## DESIGN STANDARDS BULLETIN

Appendix M – Building Signage

Date Issued: July 30, 2018

SIGN TYPE J  
BRaille EXIT SIGN

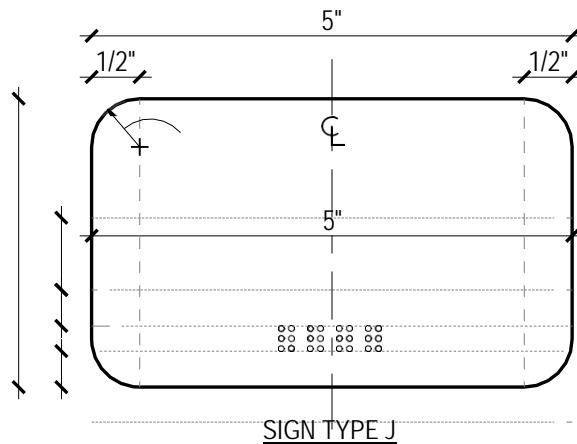
Signage in the exit stairwells, Sign Type K was incorrect per the current code.

Revise sign types J, K and K.1 per the attached.

REFER TO 2012 IBC 1011.4 RAISED CHARACTER AND BRaille EXIT SIGNS

BRaille SHALL BE CONTRACTED  
(GRADE 2) AND SHALL COMPLY WITH  
ADA 703.3 BRaille - TYPICAL
